**ORDINANCE 506**

**AN ORDINANCE OF THE CITY COUNCIL OF THE CITY OF SAN RAMON  
AMENDING THE CITY ZONING MAP TO EXPAND THE CROW CANYON  
SPECIFIC PLAN BOUNDARY AREA AND ADOPTING DEVELOPMENT  
STANDARDS AND ZONING REGULATIONS (SPA 20-800-001 & IS 20-250-001)**

**Exhibit 2 - Errata Summary Table of Refinements and Clarifications to the Crow Canyon Specific Plan Update  
November 2, 2020**

Exhibit 1: Rezone Map

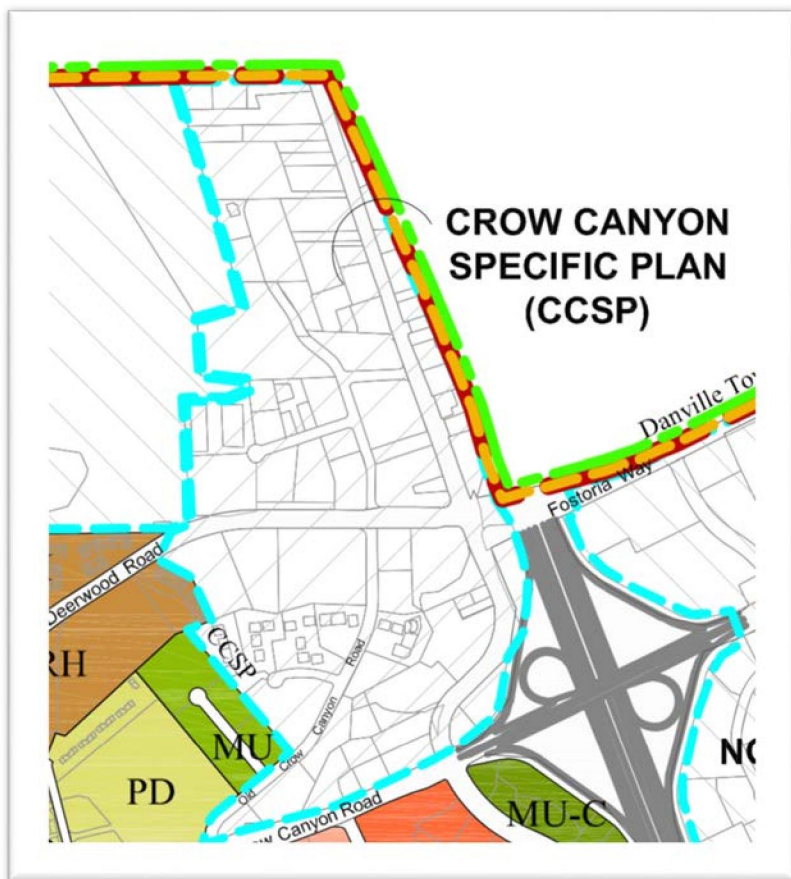
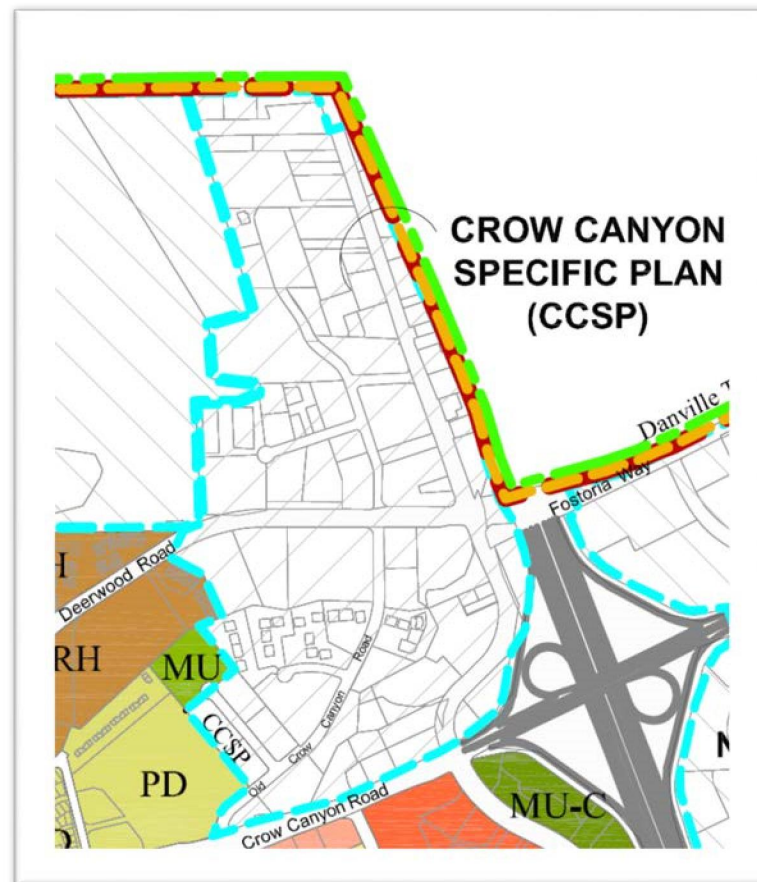
Section 1. The Zoning Map (Appendix A to the Zoning Ordinance) shall be amended to designate the real property located within the Crow Canyon Specific Plan to those designations as indicated on the attached Exhibit 1.
